**Addendum No. 2**

**CAPTAIN HENDRY HOUSE DECK RECONSTRUCTION**

**BID NO. 2021-03**

**June 24, 2021**

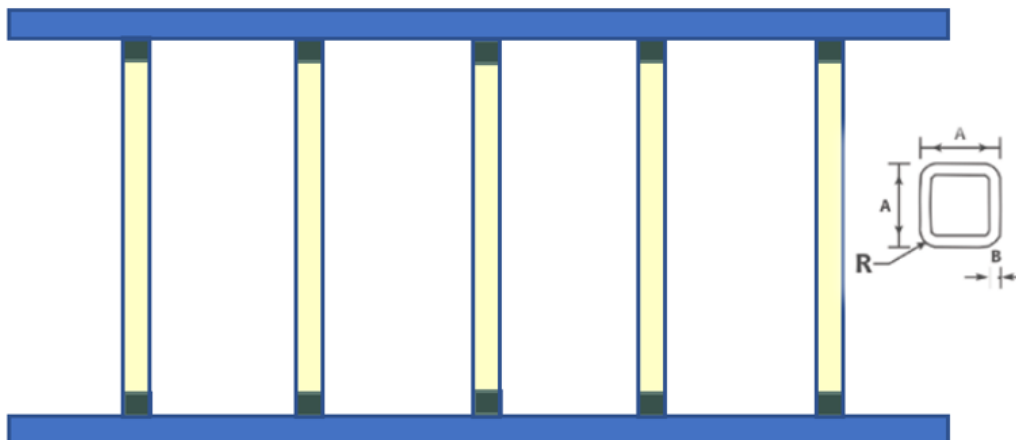
2. The skirting around the building shall be replaced with a longer skirting approximately 26” to eliminate the need for lattice as shown in the photo below. Marine plywood may be used for a back piece provided a durable exterior caulk like *Dymonic 100* is used to prevent water from being trapped between the plywood and “dental” work.
